**Town of Vernon
Design Review Commission (DRC)
Wednesday, September 1, 2021
7:00 P.M.
Council Chambers
Vernon Town Hall
14 Park Place, 3rd floor
Vernon, CT**

Application **PZ 2021-08** is an application of A. Vets Real Estate, LLC requesting a modification to an approved site plan and a special permit pursuant to section 4.10.4.11.6 to permit lot coverage in excess of 40% for a 1.19-acre parcel located at 965 Hartford Tpke (Assessor ID 26, Block 72, Parcel 0031H) and a .43-acre portion of a parcel located at 933 Hartford Tpke (Assessor ID 26, Block 72, Parcel 0031J).

SITE PLAN
PREPARED FOR
A. VETS REAL ESTATE, LLC
965 HARTFORD TURNPIKE
VERNON, CONNECTICUT

Re: Site Plan of Development, A. Vets Real Estate, 965 Hartford Turnpike, Vernon, Connecticut –
PZ-2021-08

EROSION & SEDIMENT CONTROL PLAN
PREPARED FOR
A. VETS REAL ESTATE, LLC
965 HARTFORD TURNPIKE
VERNON, CONNECTICUT

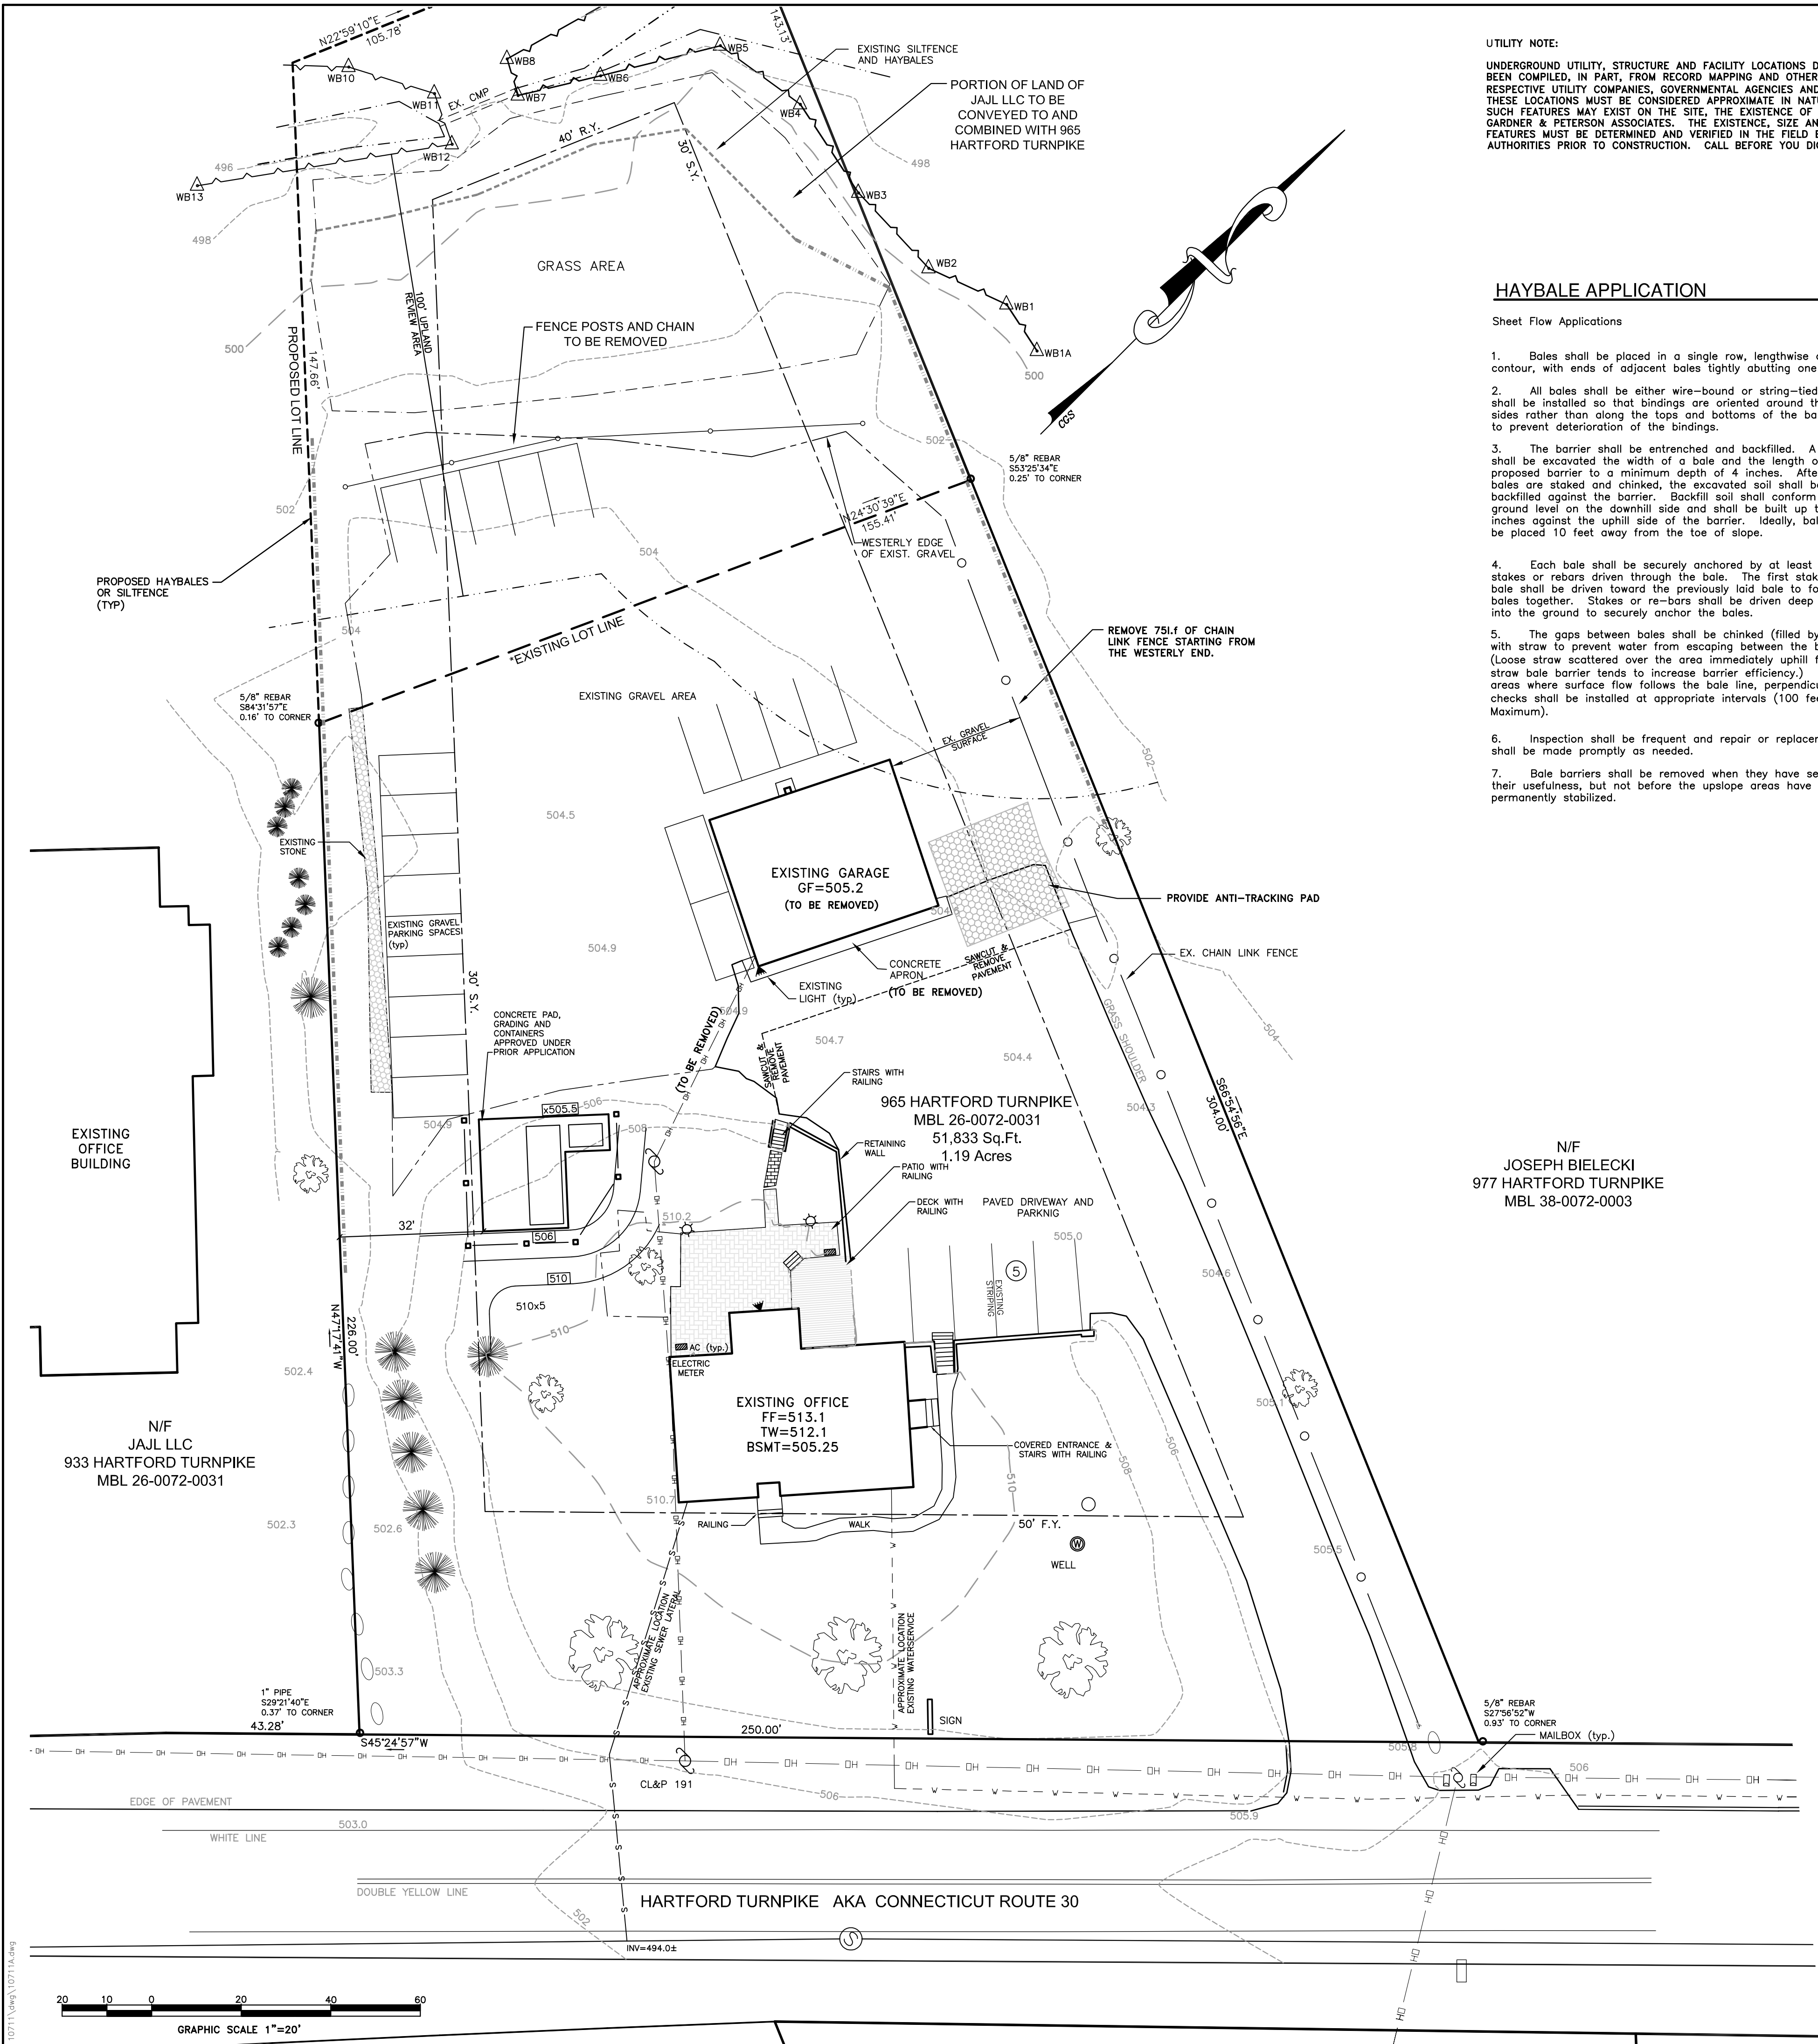
The Plan shows removal of an existing garage and proposes the construction of a larger 70' by 60' garage with associated improvements to parking and stormwater treatment. Most of the proposed improvements to parking and stormwater treatment will be built on 0.43 acres of 933 Hartford Turnpike abutting the rear of the 965 Tolland Turnpike parcel. To the north and west, a watercourse with associated wetlands borders the proposed stormwater management area. Proposed soil erosion and sediment control (E&S) measures include an anti-tracking pad and show both existing and proposed silt fence and hay bales.

The use of silt fence and hay bales as perimeter control measures is adequate and appropriate for this site. However, the "existing silt fence and hay bales" shown on the plan have not been maintained. Hay bales have deteriorated and fencing has fallen resulting in gaps.

No E&S measures were in place around a soil stockpile located near the northwest corner of 965 Tolland Turnpike. Wood chips had been deposited northwest of the stockpile and at the edge of the wetland.

- Repair &/or replace the existing silt fence and hay bales.
